Work Order ID 150884

Item Name: Plate

APICAL INDUSTRIES, INC.	ENGINEERING CHANGE NOTICE NO. 02865				SHEET 1 OF 1	
	DWG NO. 647.4200	REV: N/C	PREPARED BY R. ROSANO	DATE: 05/05/10	EFFECT ON DWG ☐ INC. ☒ UNINC.	
	DWG TITLE: BRACKETS					
	APPROVED BY: ENGR <i>[Signature]</i>	MDR <i>[Signature]</i>	QC <i>[Signature]</i>	EFF: CURRENT ORDER		
TRANSACTION CODES (TC): A-ADD C-CREATE R-REVISE D-DELETE	REASON: CHANGED PRETREATMENT CALLOUT, MODIFIED VIEWS, ADDED VIEW FOR CUT

SHEET 1, ZONE A1 IS:

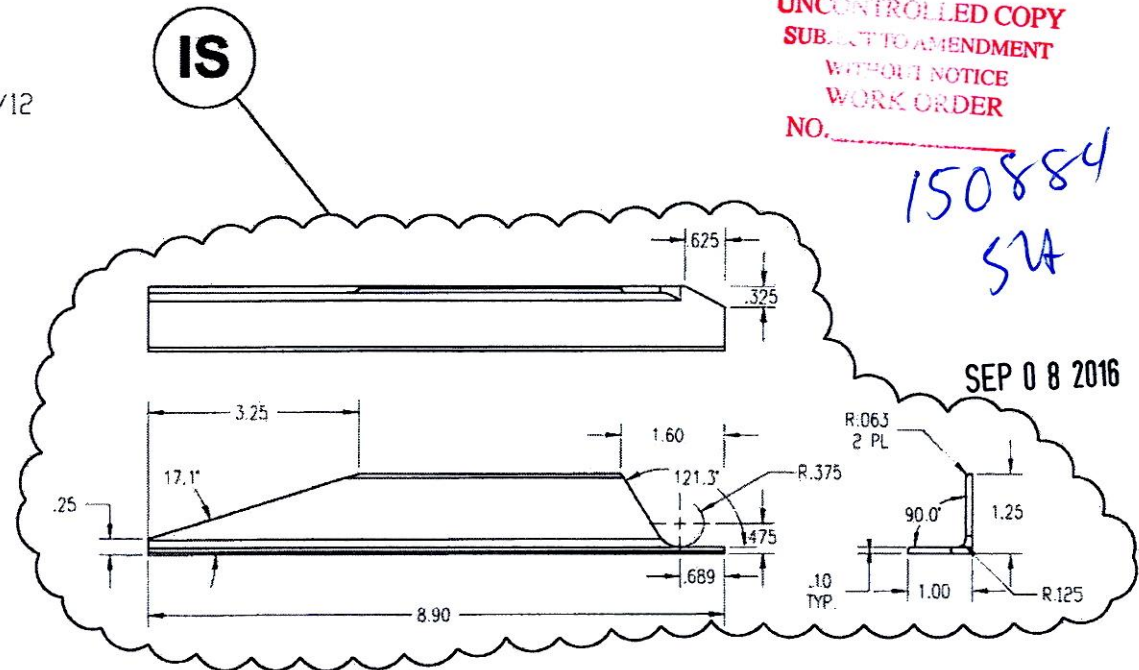
1. MATERIAL: ALUMINUM 7075-T651 PER AMS-QQ-A-250/12
2. FINISH: HARD ANODIZE IAW MIL-A-8625 TYPE III, CLASS 2, COLOR BLACK; PRETREAT PR-148 ADHESION PROMOTER PRIME IAW MIL-P-23277 TYPE I CLASS N
3. DEBURR AND BREAK ALL SHARP EDGES
4. IDENTIFY IAW MPP-120

1. MATERIAL: ALUMINUM 7075-T651 PER AMS-QQ-A-250/12
2. FINISH: HARD ANODIZE IAW MIL-A-8625 TYPE III, CLASS 2, COLOR BLACK; CARDINAL 4860-50 PRETREATMENT PRIMER PRIME IAW MIL-P-23377J TYPE I CLASS N
3. DEBURR AND BREAK ALL SHARP EDGES
4. IDENTIFY IAW MPP-120
